Item No. 16 SP 2/2018 – Proposed Secondary Plan for Precinct ‘G’ of the Complete Communities Direction Strategy – First Reading (Old Kildonan Ward)

Title: SP 2/2018 – Proposed Secondary Plan for Precinct ‘G’ of the *Complete Communities Direction Strategy* – First Reading

APPENDIX 'A' – Planning Discussion

FILE: SP 2/2018 (By-law 5/2018)

Figure 5: Proposed Rail Crossings in Precinct 'G' (Murray Avenue currently has a crossing)

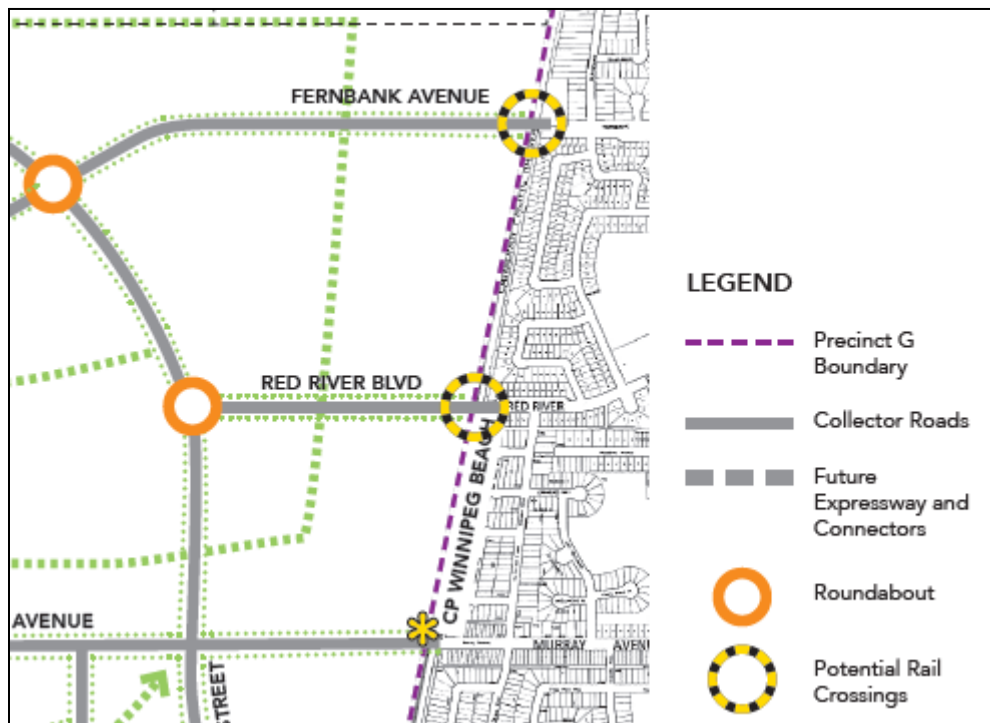
- The Transportation Study assumes the following three rail crossings over the Canadian Pacific Railway (CPR) Winnipeg Beach Subdivision in Precinct 'G' (see Figure 5):
 - Fernbank Avenue
 - Red River Boulevard West, and
 - Murray Avenue (which currently exists).

- Similarly, the Transportation Study for Precinct 'G' assumes three new rail crossings can be constructed across the Canadian Pacific Railway (CPR) corridor to the east of Precinct 'G'. There is no guarantee that the CPR will agree to this. If one or more of the three rail crossings that are proposed in Precinct 'G' are not supported by the CPR, then congestion at other access points could be significant and the Transportation Study will need to be updated and the Plan may need to be amended.

- The City's recent experience is that Canadian Pacific is not in favour of new at-grade railway crossings. Recently, during the planning stages of Precinct K, a new at-grade railway crossing was not approved and the Plan for Precinct K, including the Transportation Study, was amended to reflect this.

Figure 6: Projected Annual Average Daily Traffic on Adjacent Streets

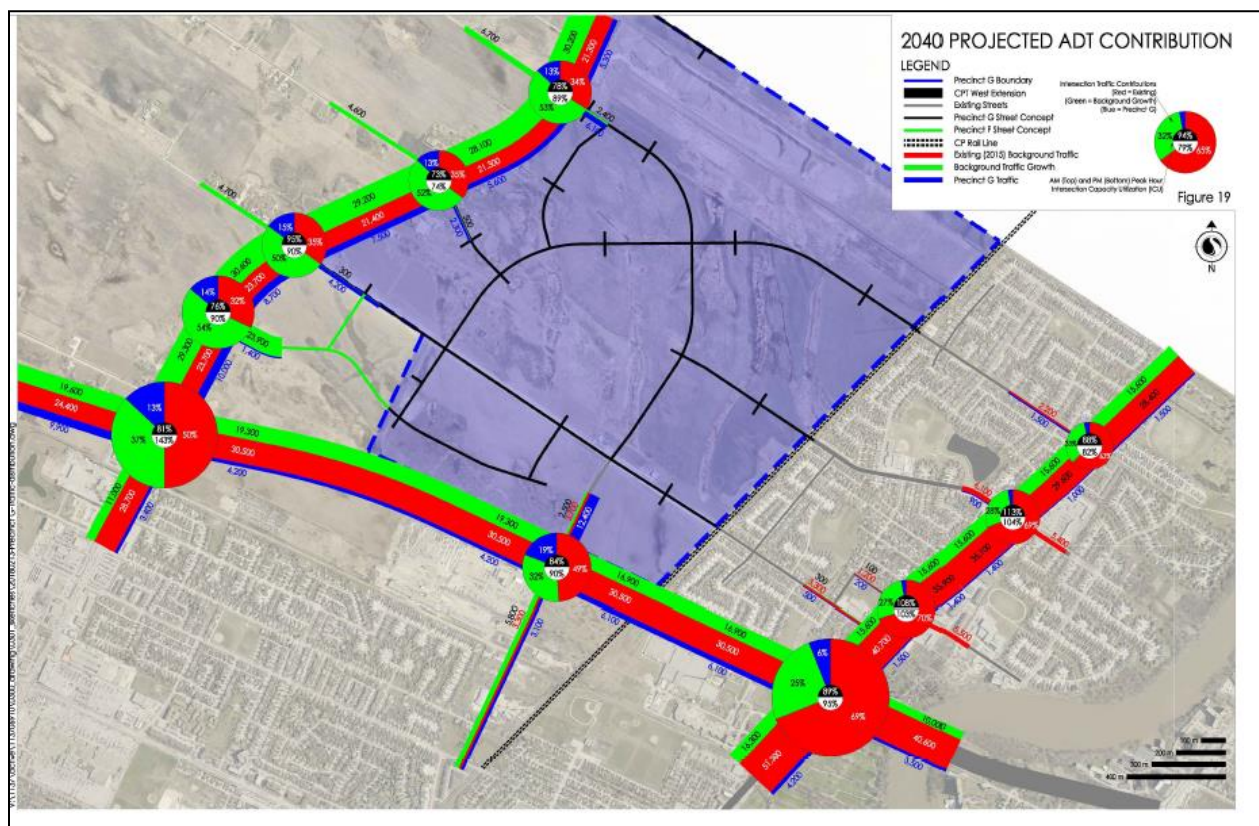
- The Transportation Study for Precinct 'G' relies heavily on Chief Peguis Trail for access. If Precinct 'G' builds out ahead of Chief Peguis Trail being extended, then congestion at other access points could be significant and the traffic study will need to be updated.

- The Transportation Study for Precinct 'G' notes significant background traffic growth from communities outside of Winnipeg in the future (see Figure 6). This growth, and not Precinct 'G' traffic, make up the majority of forecast traffic growth on McPhillips Street and Main Street, triggering the need for major widening projects, which have not been studied and are currently not budgeted for. If these do not occur, traffic congestion could become significant throughout the northwest sector of Winnipeg.

- Regional improvements, such as the widening of McPhillips Street or Main Street to six lanes and the extension of the Chief Peguis Trail are additional costs to the City.

Figure 7: Land Use Policy Area Map

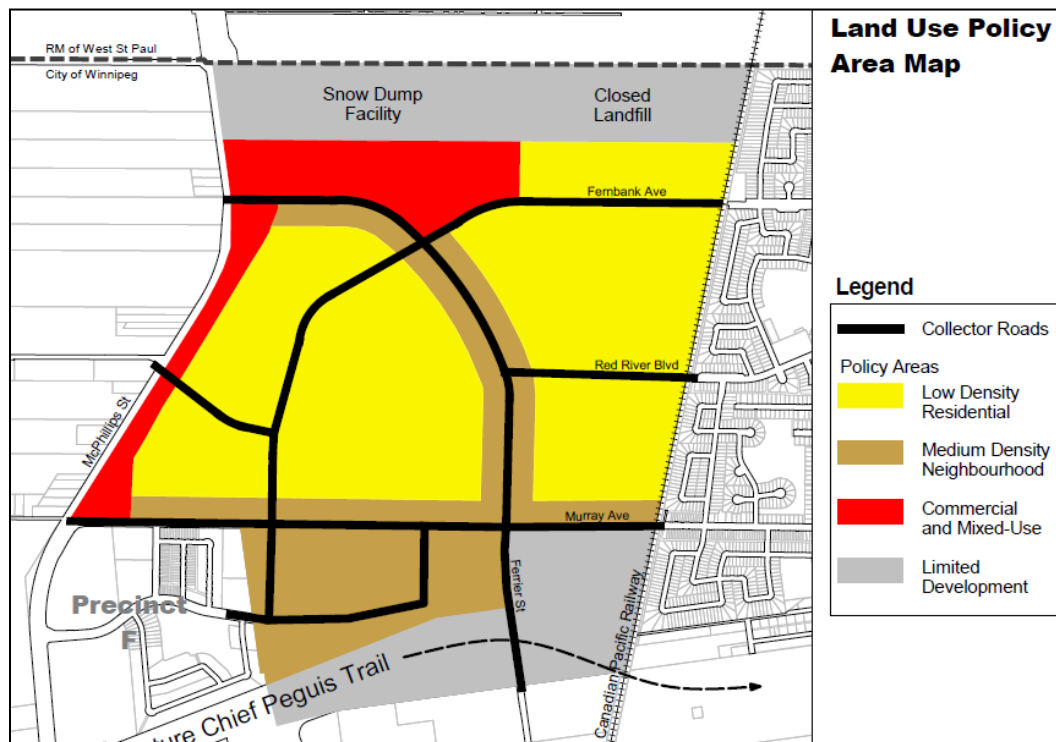
- As previously discussed, the Transportation Study assumes a fairly aggressive modal split of 10% for transit use in a new community.
- The Public Service identified challenges with the proposed configuration of the Medium Density Neighbourhood Policy Area in terms of achieving a 10% modal split, namely because the proposed Medium Density Neighbourhood Policy Area serves to address issues with *coverage*, not *ridership* or *frequency* of Transit.
- In order to remedy this issue, the Public Service proposed that the Medium Density Neighbourhood Policy Area be concentrated predominantly along Murray Avenue and south of Murray Avenue, west of Ferrier Street (see Figure 7).

- Consolidating the Medium Density Neighbourhood Policy Area south of and along Murray Ave. creates a dense node within the community. Such nodes are attractive targets to serve with public transit compared to spread-out, low density suburban areas. This makes it more likely that more frequent Transit service would be provided by Winnipeg Transit (subject to resources being available) since higher demand for service warrants more frequent service, and more frequent Transit service could increase the potential of reaching a modal split of 10% for public transit.

Figure 8: Proposed Land Use Policy Area Map (Medium Density Neighbourhood Policy Area in dark pink)

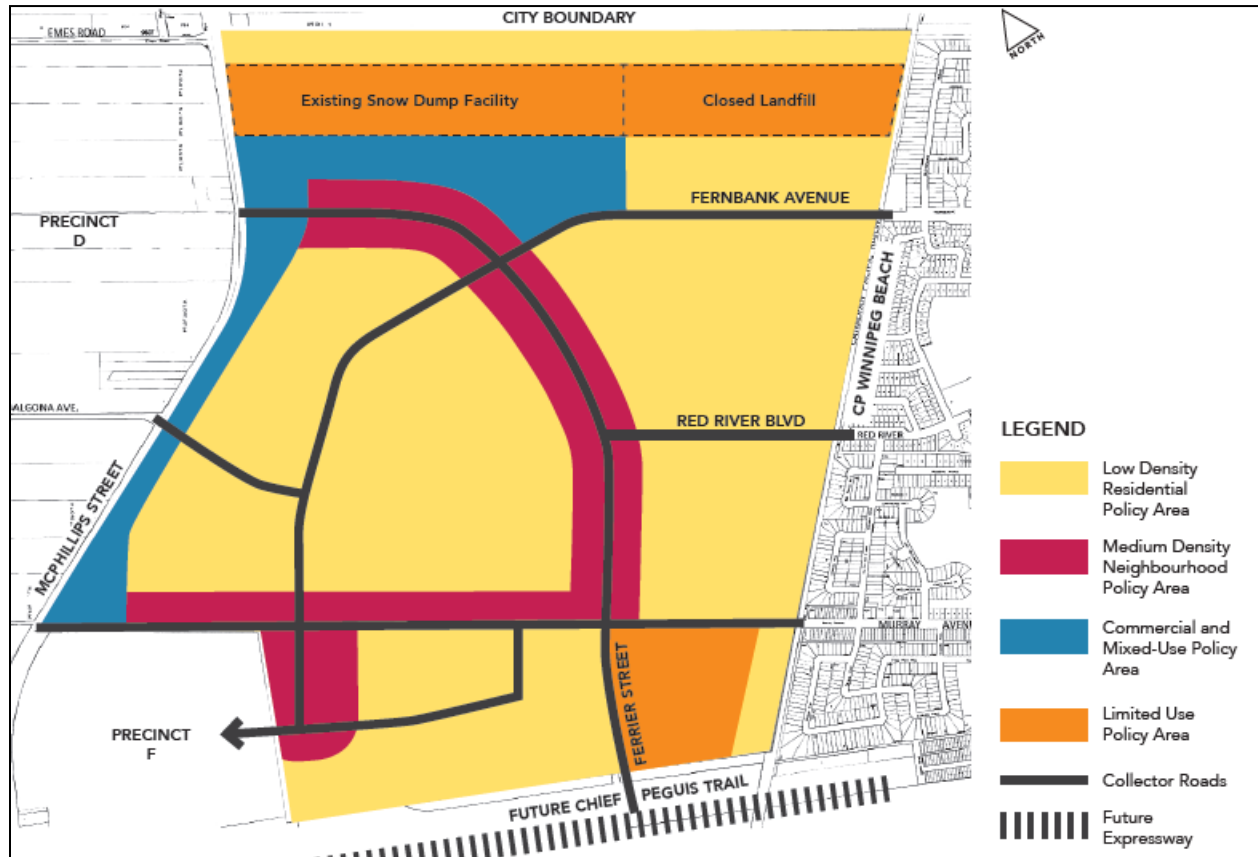
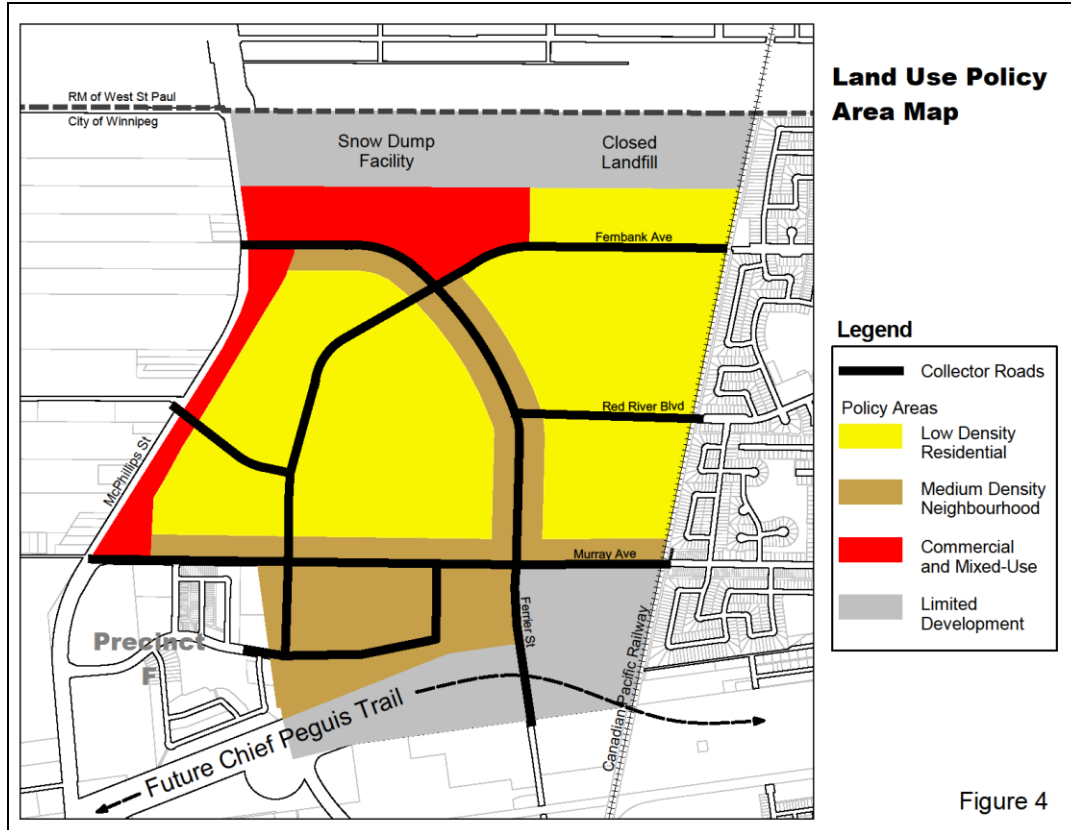
- The applicant's response was to include most of the Ferrier Street extension and the north side of Murray Avenue as part of the Medium Density Neighbourhood Policy Area in the application (see Figure 8). Further, the following additional policies were added that can potentially erode density in this policy area:

- While the Public Service is supportive of keeping most of Ferrier Street designated as Medium Density Neighbourhood, concerns remain over not including a concentrated area of multi-family development south of Murray Avenue.
- Not having a concentrated area of multi-family development limits the potential to achieve the 10% modal split as assumed in the supporting Transportation Study.
- Further, proposed policy 3.2.3(c) can potentially erode the desired density to help achieve the assumed modal split of 10% as it allows for single-family dwellings to back onto collector roads. This is undesirable both from a density and urban form perspective.

c) *It is not fronting onto a collector road.*”
 be deleted and replaced with the following:
 3.2.3 *Single-family housing is discouraged, but may be accommodated when it has been demonstrated that a net density of 20 units per acre can be achieved throughout the Medium Density Neighbourhood Policy Area.*

- iii. That, *Figure 4 “Land Use Policy Map”* of the proposed Plan be deleted and replaced with *Figure 4: Land Use Policy Area Map* as provided in *Figure 9 - Land Use Policy Area Map (Revised)* of this Planning Discussion.

Figure 10: Proposed Land Use Policy Area Map

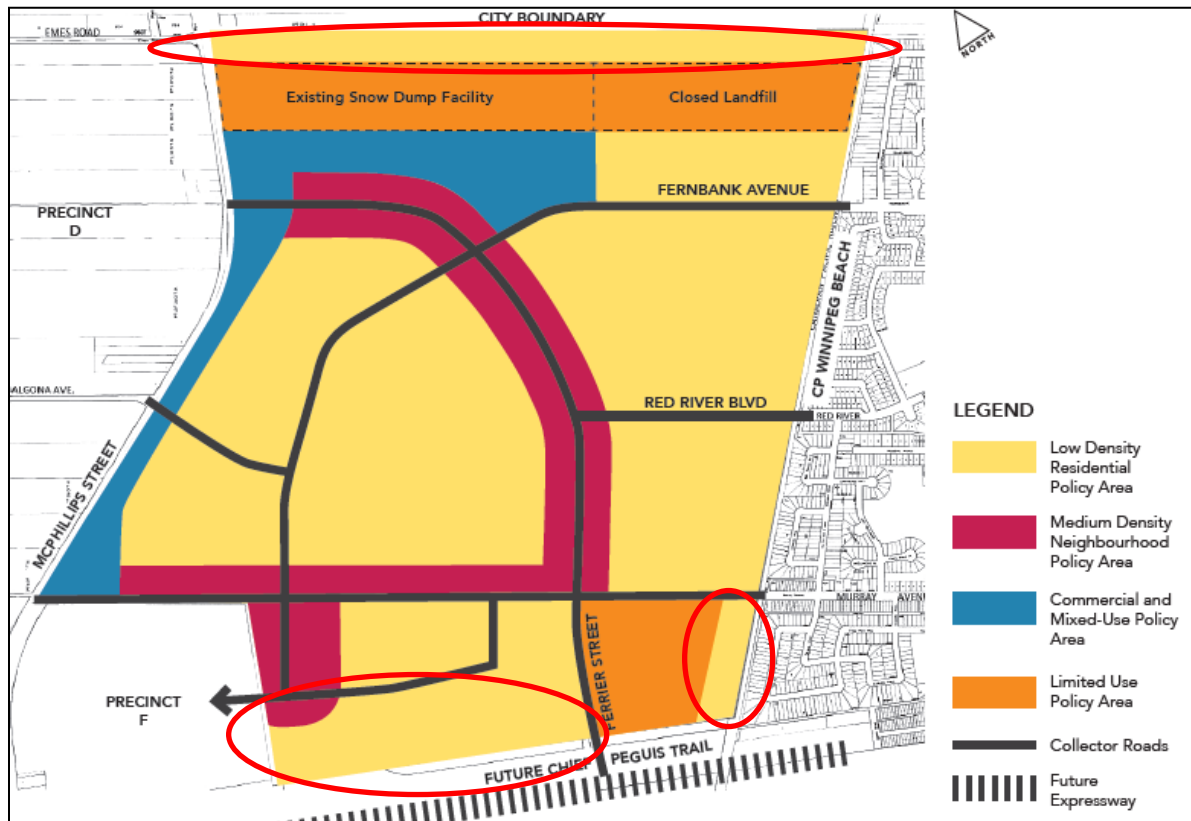
- As currently proposed, the Limited Development Policy Area only pertains to lands owned by the City of Winnipeg:
 - The McPhillips snow dump
 - A closed landfill (immediately east of the snow dump)
 - Lands owned by the City of Winnipeg (Part Lot 2 Plan 16344 and other nearby lots) where there are currently long-terms plans for a support-type land use related to the North End Sewage Treatment Plant.
- In meeting with the applicant in the fall of 2017, the Public Service identified the City-owned lands mentioned above as being included in the Limited Development Policy Area, but also included the following locations (see areas circled in red in Figure 10):
 - Land immediately north of the snow dump
 - Land between the Part Lot 2 Plan 16344 and the CPR Winnipeg Beach Subdivision
 - Lands that could be impacted by the future Chief Peguis Trail extension alignment, west of Ferrier Street.

- The reasons the Public Service recommended including these lands within the Limited Development Policy Area were:
 - Land immediately north of the snow dump

- Land between Part Lot 2 Plan 16344 and the CPR Winnipeg Beach Subdivision
 - These lands may be impacted by the future Chief Peguis Trail alignment and there are currently long-term plans for a support-type land use related to the North End Sewage Treatment Plant near this location.

- Lands that could be impacted by the future Chief Peguis Trail extension alignment west of Ferrier Street
 - The Chief Peguis Trail (CPT) alignment has not been finalized. As such, it is premature and irresponsible for the Plan to designate lands in the vicinity of the CPT as having more development potential than they currently possess.

3.4.6 The boundary of the Limited Development Policy Area in sub-area 4a will be consistent with that of the Future Chief Peguis Trail right-of-way once the alignment of the Chief Peguis Trail has been approved by Council.
- iii. That, under section 3.4 *Limited Development Policy Area* the following policy be added after policy 3.4.6:

3.4.7 Existing agricultural uses may continue to operate in the Limited Development Policy Area.
- iv. That, *Figure 4 “Land Use Policy Map”* of the proposed Plan be deleted and replaced with *Figure 4: Land Use Policy Area Map* as provided in Figure 9 of this Planning Discussion.

Figure 11: Commercial and Mixed-Use Policy Area (in blue) Short of Meeting Ferrier Street (circled in red)

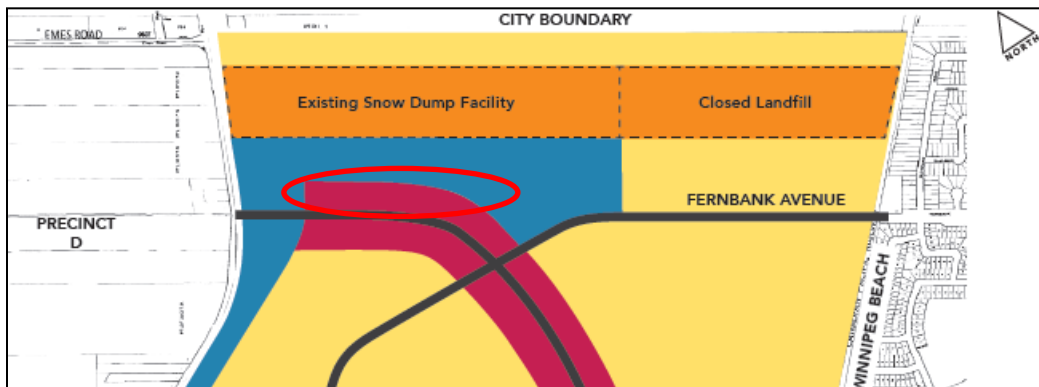
- Allowing for new single-family residential development is inconsistent with virtually all of the intent statements above.
- Secondly, the Commercial and Mixed-Use Policy Area in the northwest corner of the site stops short of meeting Ferrier Street. Instead, this area is designated as Medium Density Neighbourhood, which is intended to primarily allow for more intense residential development (see Figure 11).

- Per the intent statement – *to provide a buffer between the City of Winnipeg snow dump and residential uses* – the purpose of the Commercial and Mixed-Use Policy Area in this location is to allow for non-residential development to occur that can provide a buffer from the snow dump. The Public Service therefore recommends extending the Commercial and Mixed-Use Policy Area to the northern extent of Ferrier Street.

- i. That, under section 3.3 *Commercial and Mixed-Use Policy Areas*, policy 3.3.7:
 “Single-family housing may be permitted in the Commercial and Mixed-Use Policy Area if it:
 - *Does not front onto a collector road or arterial road; and,*
 - *Is not within approximately 50 meters of an arterial road and collector road intersection.”**be deleted and replaced with the following:*
 3.3.7 *New single-family dwellings will not be permitted in the Commercial and Mixed Use Policy Areas.*
- ii. That, *Figure 4 “Land Use Policy Map”* be deleted and replaced with *Figure 4: Land Use Policy Area Map in Figure 9 of this Planning Discussion.*

Figure 13 – Sub-Areas & Phasing Map (Revised)

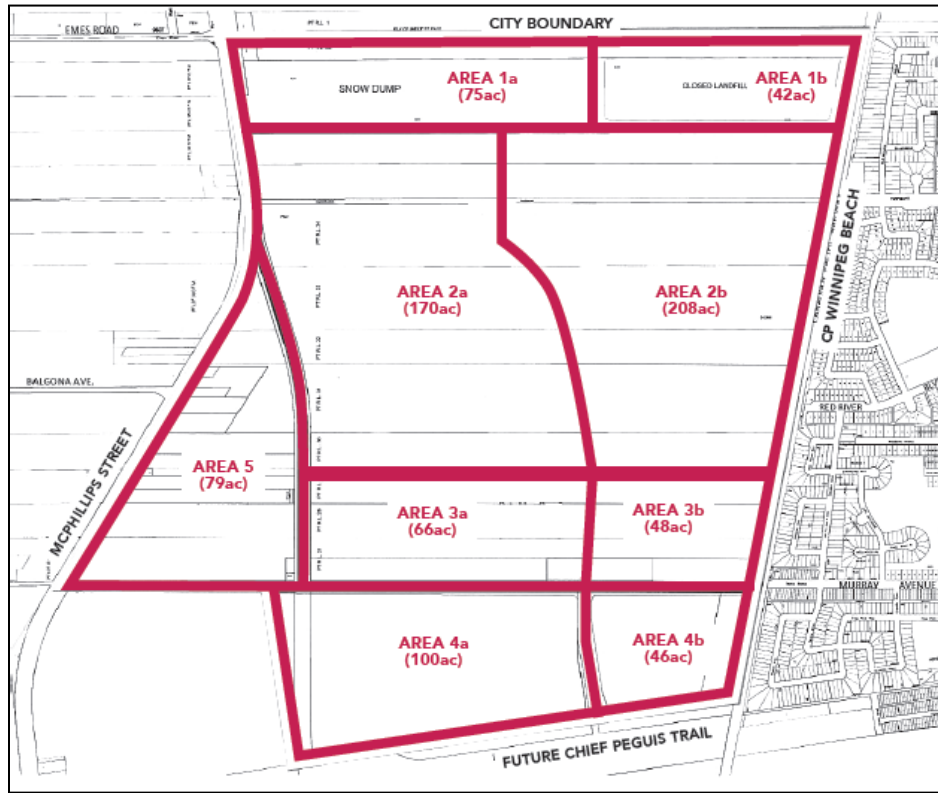
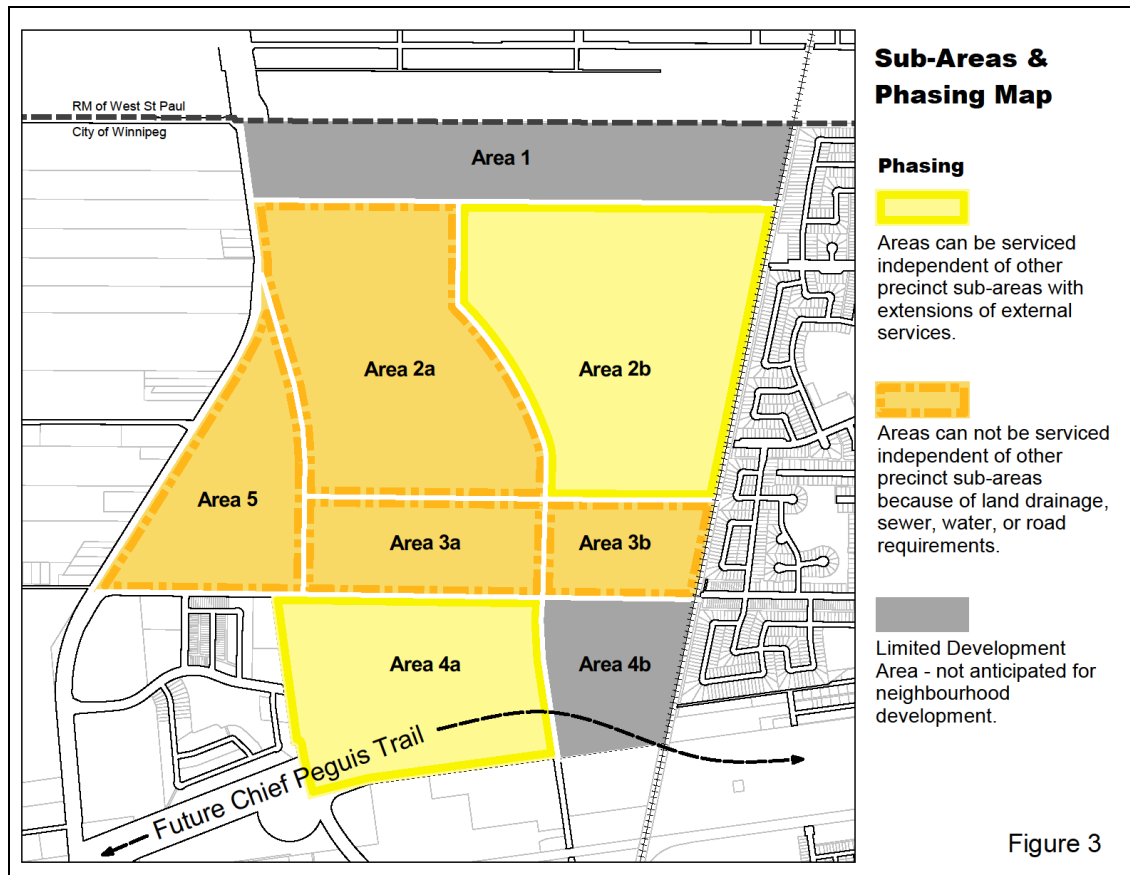
- The proposed phasing plan as identified in the *Staging and Phasing Policies* (section 6) and *Figure 7 – Phasing Map* indicates that the area near the northwest portion of the site (referred to as Area 2a – see Figure 12 below) can be serviced independent of other areas.

- The Public Service has several concerns with development potentially beginning in the northwest portion (2a) of the site or for development being contemplated as possible to be serviced independently from other areas:

- The phasing proposed in the Plan – particularly that sub-area 2a in the northwest can be serviced independently – is not supported by the Municipal Servicing Brief.
- Servicing sub-area 2a in advance of sub-area 2b is expected to result in increased maintenance and operations costs to the City of Winnipeg compared to contiguous development.

- i. That, Figure 7 “*Phasing Map*” be deleted.
- ii. That, *Figure 3 “Precinct G Sub-Areas”* of the proposed Plan be deleted and replaced with *Figure 3: Sub-Areas and Phasing Map* as provided in Figure 13 – *Sub-Areas & Phasing Map (Revised)* of this Planning Discussion.

*The policies of this section serve to ensure that the orderly development of the Precinct can be accommodated by appropriate infrastructure. The phasing plan for Precinct G is illustrated in **Figure 3 (Sub-Areas and Phasing Map)**. Development phasing within the Precinct is primarily based on infrastructure requirements (including roads, water, wastewater, and land drainage) on a sub-area basis. The Plan assumes that a majority of development will take place over a 25-year time horizon.*

*Phasing for development of each Sub-Area within the Precinct is subject to the following constraints as outlined in **Figure 3 (Sub-Areas and Phasing Map)**.*

- Sub-areas 2b and 4a identified as yellow in Figure 3 can be serviced independent of other Precinct sub-areas with minor extension of services. More specifically, sub-area 2b can be serviced to accommodate single-family dwellings. However, the Servicing Brief has not demonstrated that multi-family development can be adequately serviced by the water infrastructure in sub-area 2b without additional connections to the south or southwest. Further review is required to confirm the extent of multi-family development in sub-area 2b prior to connections to the south. Per policy 3.4.5, no neighbourhood development will be permitted in the southern portion of sub-area 4a until the alignment of the Future Chief Peguis Trail right-of-way has been determined and approved by Council.

- Sub-area 2a, identified as orange in Figure 3, cannot be serviced independent of other Precinct sub-areas because of land drainage, sewer, or water.
- Sub-area 3a, identified as orange in Figure 3, cannot be serviced independent of other Precinct sub-areas because of land drainage.

- Sub-areas 5 and 3b, identified as orange in Figure 3, cannot be fully serviced independent of other Precinct sub-areas.
- Sub-areas 1 and 4b identified as grey in Figure 3, have limited development potential. Area 1 is predominantly comprised of an operational snow dump with no plans to cease operations in the foreseeable future and a closed landfill. The closed landfill may be considered in the future as a passive park space. The majority of Area 4b is required for long-term plans to develop a support-type land use related to the North End Sewage Treatment Plant and some of the lands may be required for the Future Chief Peguis Trail.
